Serial No. 10/729,289

Amendments to the Drawings:

The attached sheets of drawings include changes to Figs. 1, 1a and 5. These replacement sheets, which include Figs. 1, Figs. 1a and 2a, and 5, replace the original sheets of drawings.

1/6

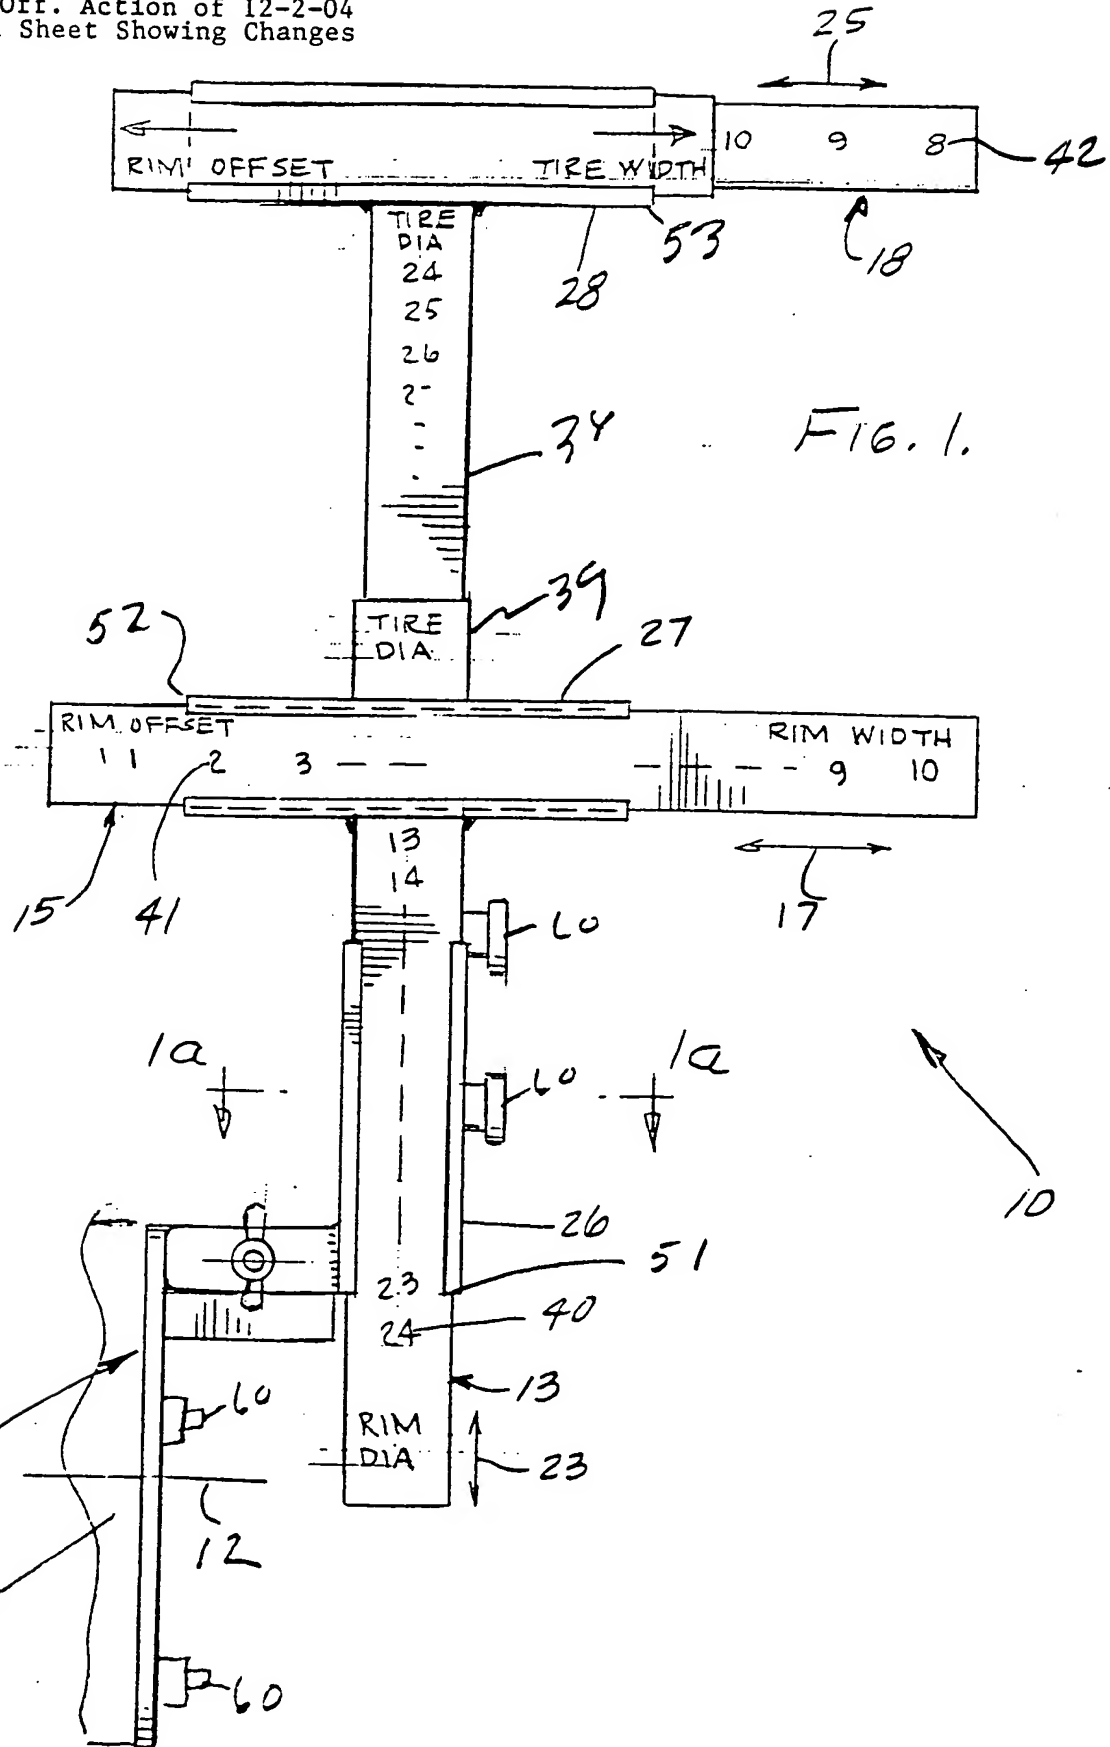
In Fig. 1, the numeral applied to the ''edge'' is now 151 instead of 51.

Changed to
151

3/6

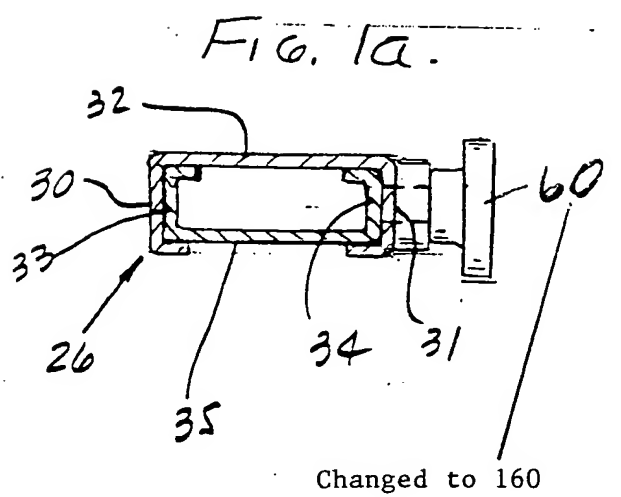
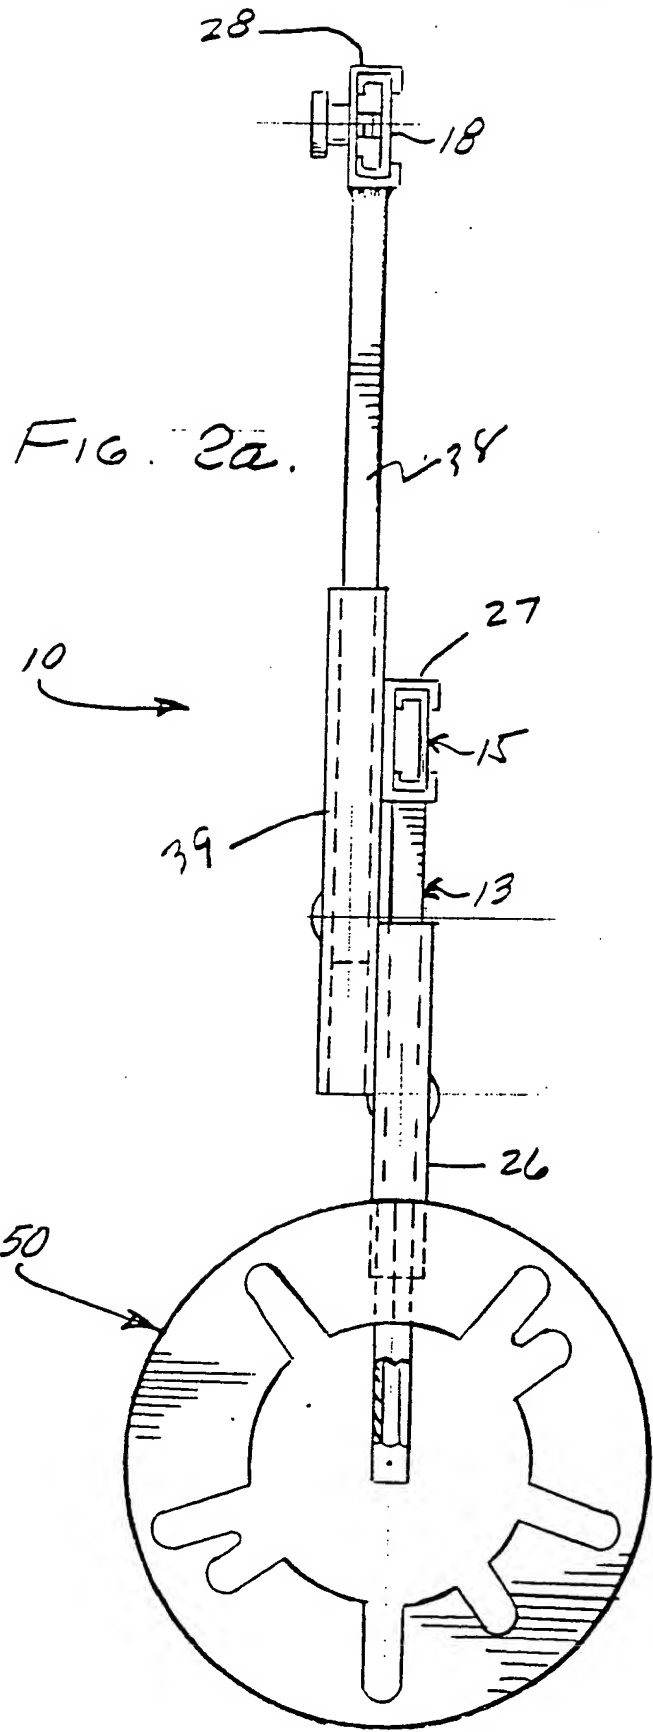
In Fig. 5, the numeral applied to the shock absorbers is now ''230'' instead of 23.
